Yan Yean Road (Stage 2) Upgrade

Minister's Assessment under *Environment Effects Act 1978*

Minister for Planning
March 2021

Figure 2. Bridge Inn Road intersection surplus land (from IAC Report)

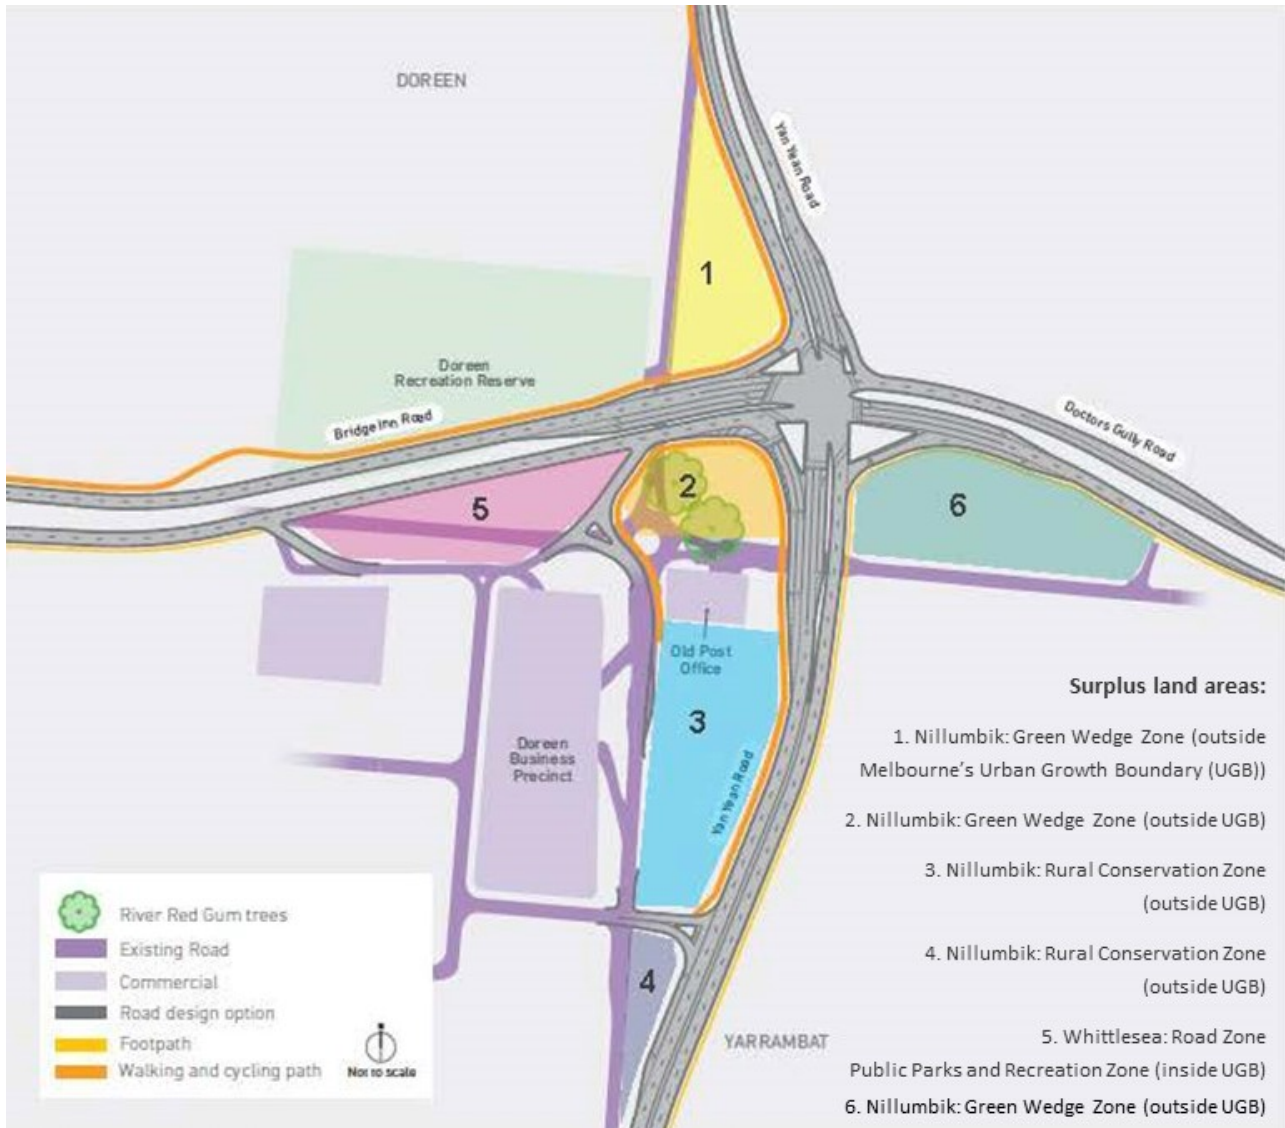
The Bridge Inn Road intersection design Option B would result in six areas of surplus land, as shown in Figure 2. The surplus land, and its ultimate use, was the subject of a number of requests from both councils during the hearing. Overall, both councils submitted to the IAC that surplus land acquired at this intersection, regardless of the final design, should be master planned to address amenity and urban design issues. MRPV accepted the councils' request for a surplus land use plan, and in response, proposed a new EPR LU3. MRPV's expert witness Mr Barlow also recommended final zones and uses for the six parcels.

The IAC determined the ultimate uses and zones for the surplus land should be determined after the road design details have been finalised and in consultation with Whittlesea and Nillumbik Councils. The IAC agreed a master plan should be prepared, with specific directions that the plan:

- consider consolidating part of Area 1 into the Doreen Recreation Reserve as part of its modified design;
- ensure that Area 3 retains clear views between the activity centre and the new road and consider land uses which would help integrate the Old Doreen Store with the rest of the activity centre and complement existing businesses; and
- inform the landscape strategy so that it can include landscaping and reinstatement works on surplus land parcels.
